## **Proposal for amendments to UN R13 and UN R13-H**

# **Mechanical locking device as an alternative to the friction parking braking to hold the vehicle**

**inf. doc. 18-08 (UN R 13) inf. doc. 18-09 (UN R13-H)**

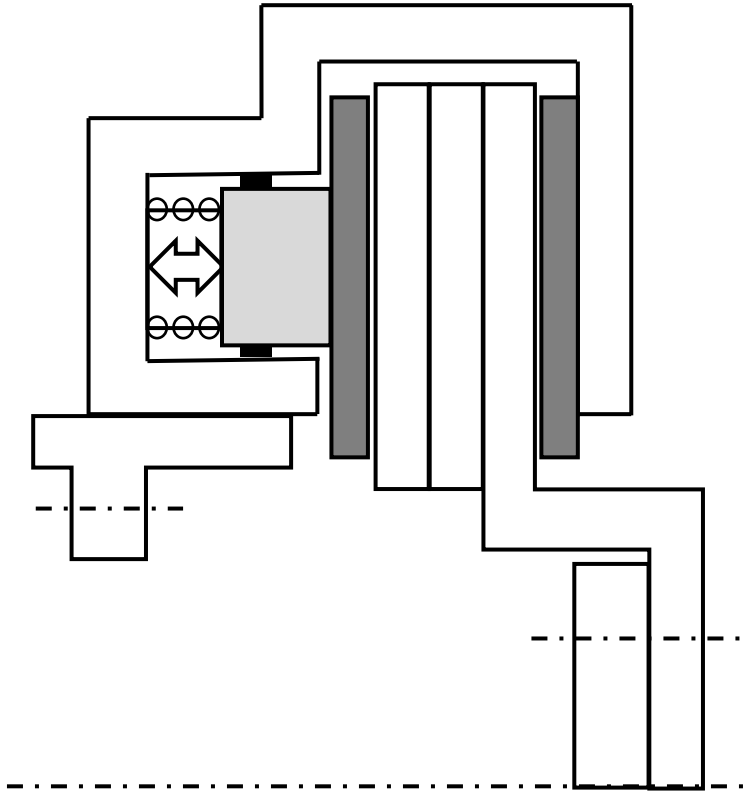
**UN R13-H, para. 5.2.2.4 ; UN R13, para. 5.2.1.2.4.**  
The parking braking system shall be so designed that it can be actuated when the vehicle is in motion. **This requirement may be met by the actuation of the vehicle's service braking system**, even partially ...

**UN R13H, annex 3, para. 2.3.6 ; UN R13, annex 4, para. 2.3.6.**  
To check compliance with ... paragraph 5.2.2.4. ...on application of the control of the parking brake system and the deceleration immediately before the vehicle stops, shall not be less than 1.5 m/s<sup>2</sup>.

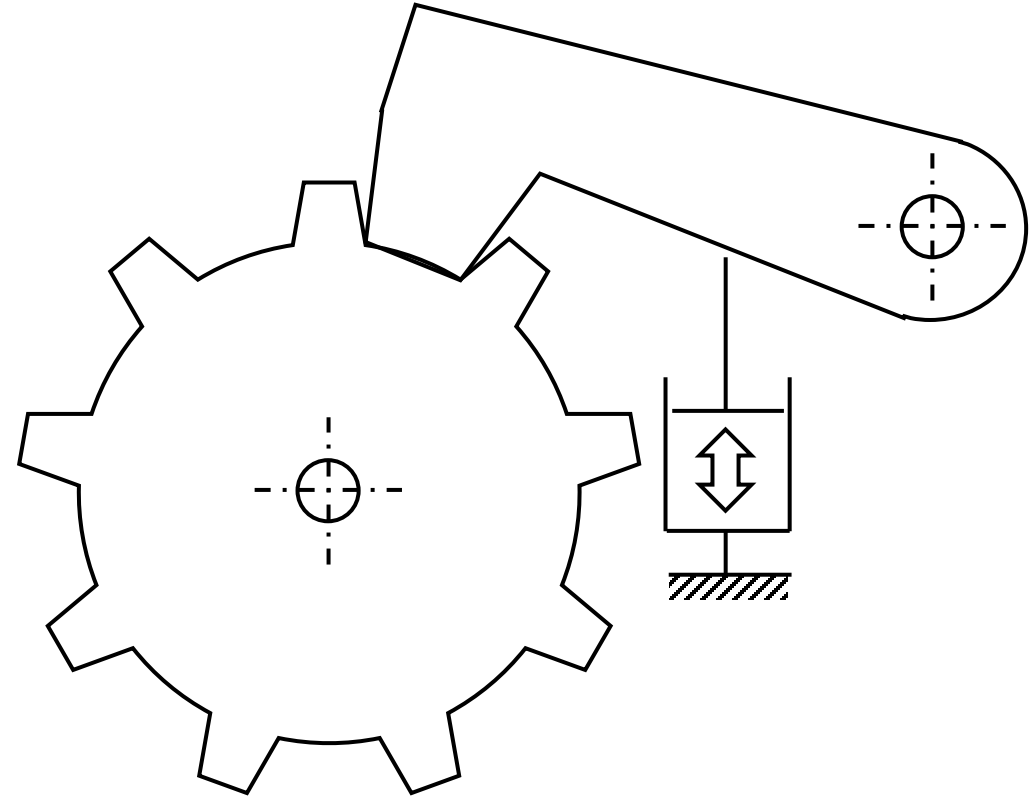
**Proposal to amend UN R13-H, para. 5.2.10. and UN R13, para. 5.2.1.10:**  
The service, secondary and parking braking systems shall act on braking surfaces connected to the wheels through components of adequate strength.  
*The parking braking system may use a mechanical locking device (e.g., gear lock, parking pawl) of adequate strength as an alternative to means acting on the braking surfaces to fulfil the requirements set out in annex 3, paragraphs 2.3.1 and 2.3.2 of this Regulation.* → for UN R13 annex 4, paragraph 2.3.1 and 2.3.2. is addressed

**The static task of the parking braking system can be fulfilled by a friction and/or locking type**
